**STAFF REPORT  
KETCHUM PLANNING AND ZONING COMMISSION  
MEETING OF SEPTEMBER 15, 2020**

**PROJECT:** Delong Townhome Design Review

**FILE NUMBER:** P20-051

**APPLICATION TYPE:** Design Review

1 NORTH ELEVATION  
SCALE: 1/4" = 1'-0"

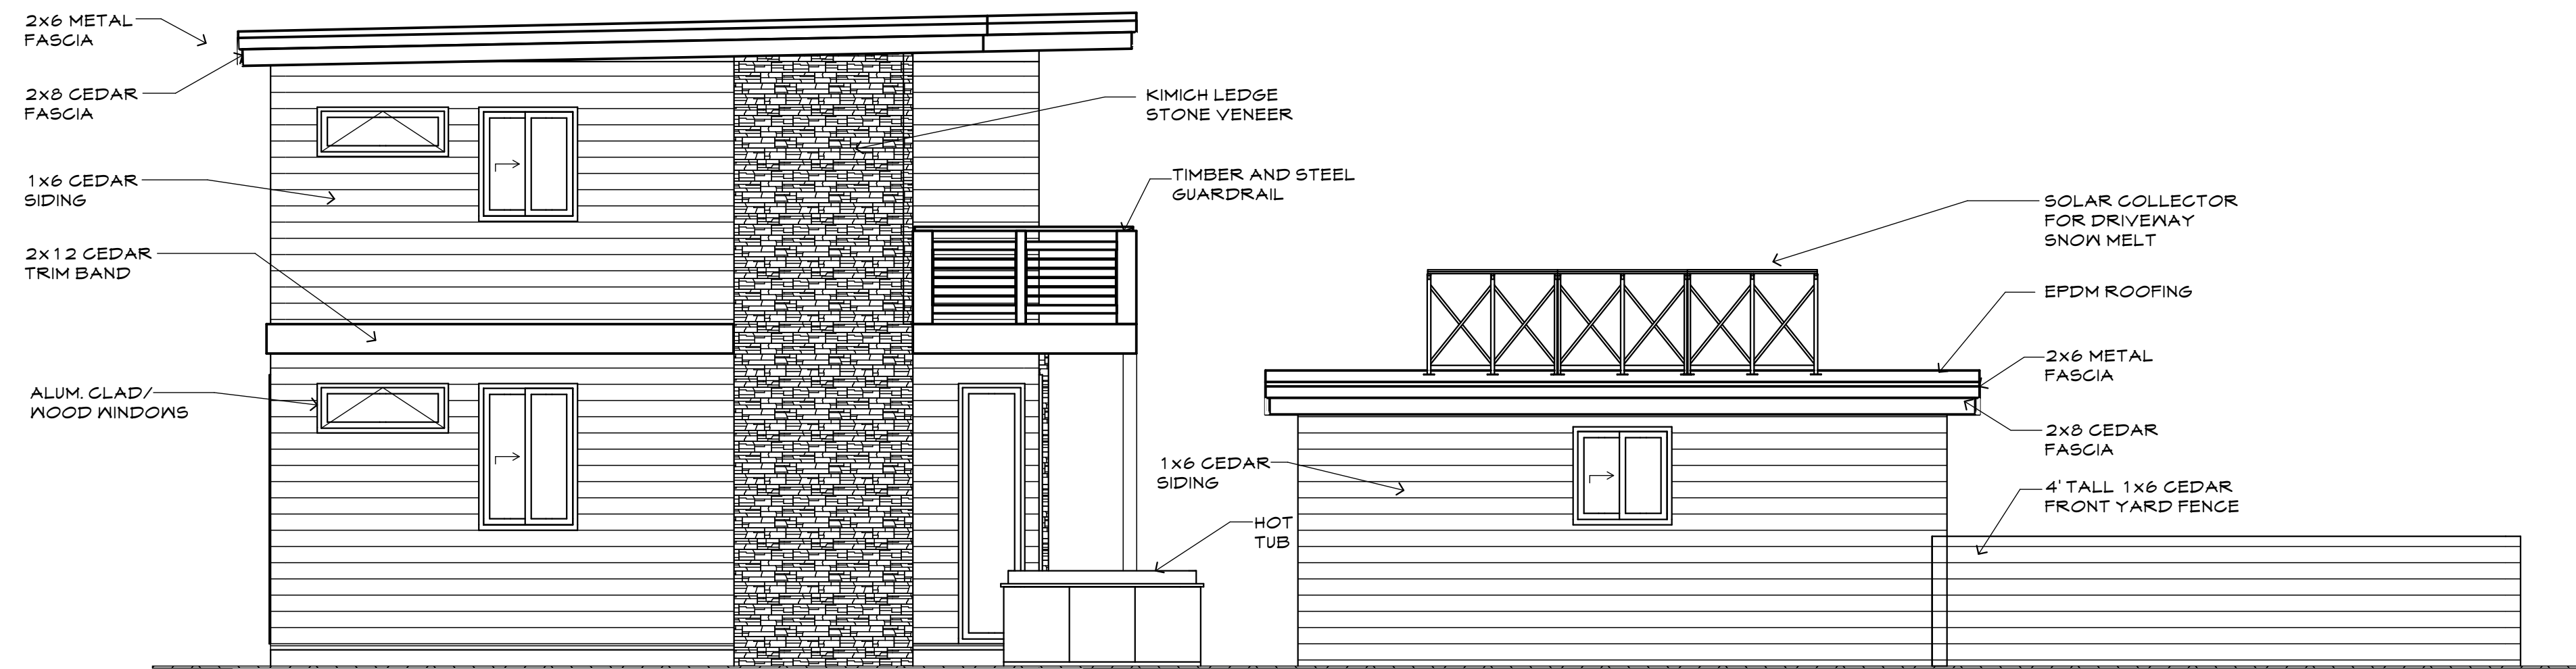
|                                     |                          |                                     | <i>Staff<br/>Comments</i>                           | <i>The elevations on Sheet 5 of the project plans note the exterior materials. The applicant has provided one colored elevation illustrating the front façade. Pictures and specifications of the proposed exterior materials have also been included in the project plans. The design utilizes natural materials and colors. The main material used across all facades of the townhome and garage is horizontal cedar siding stained with a natural tone. Two-story and one-story elements of stone veneer provide relief from the horizontally placed siding. The two-floors of the townhome unit are visually distinguished by the second-level balcony at the front elevation and a cedar trim band that wraps across all facades. Black aluminum-clad window and door openings, metal fascia, and the balcony's railing detail provide further relief from the horizontal cedar siding.</i><br><br><i>The neighboring townhome on subplot 2 is also characterized by natural materials and colors. The new townhome has a darker color palette with predominately reddish-brown stained cedar and black trim. The existing townhome has a lighter color palette with gray-tinted beige stone veneer and khaki-tan stucco with dark brown vertical siding and trim.</i><br><br><i>The project's materials and colors complement the adjacent homes and surrounding neighborhood. Homes in the surrounding</i> |

|                                     |                          |                                     | <i>Staff<br/>Comments</i>                           | <i>Building elevations are included on Sheet 5 of the project plans. Two-story and one-story elements of stone veneer provide relief from the horizontal cedar siding. The two-floors of the townhome unit are visually distinguished by the second-level balcony at the front elevation and a cedar trim band wrapping across all facades. Black aluminum-clad window and door openings, metal fascia, and the balcony's railing detail provide further relief from the horizontal cedar siding. The slight slope of the mono-pitched roof decreases the bulk of the box-shaped building.</i> |

|                                     |                          |                          | <b>Staff Comments</b>             | <p>The front and side façades incorporate material differentiation and visual relief from the bulk of the rectangular-shaped building. Two-story and one-story elements of stone veneer provide relief from the horizontal cedar siding. The two-floors of the townhome unit are visually distinguished by the second-level balcony at the front elevation and a cedar trim band wrapping across all facades. Black aluminum-clad window and door openings, metal fascia, and the balcony's railing detail provide further relief from the horizontal cedar siding. The slight slope of the mono-pitched roof decreases the bulk of the box-shaped building.</p> <p>The back wall is stark compared to the front and side elevations with only the cedar trim band, two windows, and one door opening. The existing townhome on subplot 2 is 23'-8" tall and will block this flat façade from public view.</p>   |

|   |   |   | <i>Staff Comments</i>              | <p><i>The second-level balcony extends beyond the front wall to cover the paver pathway leading to the front door. The flat roof form will prevent water from dripping or snow from sliding from the building. As noted on the east elevation (Sheet 5), the flat roof will be an EPDM system.</i></p>  |
